TVA-BFN-TS-425

**BROWNS FERRY NUCLEAR PLANT (BFN) - UNITS 2 AND 3 - TECHNICAL SPECIFICATIONS (TS) CHANGE 425 - FRAMATOME FUEL - CORE OPERATING LIMITS REPORT (COLR) REFERENCES**

Proposed Technical Specifications Changes (mark-up)

5.6.5 CORE OPERATING LIMITS REPORT (COLR)

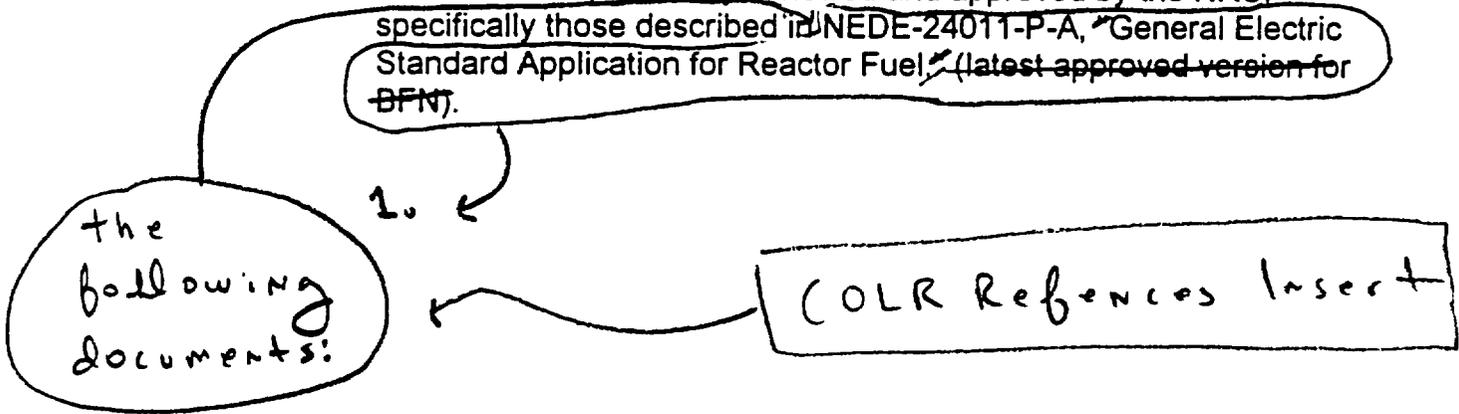
- a. Core operating limits shall be established prior to each reload cycle, or prior to any remaining portion of a reload cycle, and shall be documented in the COLR for the following:
- (1) The APLHGRs for Specification 3.2.1;
  - (2) The LHGR for Specification 3.2.3;
  - (3) The MCPR Operating Limits for Specification 3.2.2; and
  - (4) The RBM setpoints and applicable reactor thermal power ranges for each of the setpoints for Specification 3.3.2.1, Table 3.3.2.1-1.

- b. The analytical methods used to determine the core operating limits shall be those previously reviewed and approved by the NRC, specifically those described in NEDE-24011-P-A, "General Electric Standard Application for Reactor Fuel" (latest approved version for BFN).

### COLR References Insert

2. XN-NF-81-58(P)(A), RODEX2 Fuel Rod Thermal-Mechanical Response Evaluation Model.
3. XN-NF-85-67(P)(A), Generic Mechanical Design for Exxon Nuclear Jet Pump BWR Reload Fuel.

4. EMF-85-74(P)(A), RODEX2A (BWR) Fuel Rod Thermal-Mechanical Evaluation Model.
5. ANF-89-98(P)(A), Generic Mechanical Design Criteria for BWR Fuel Designs.
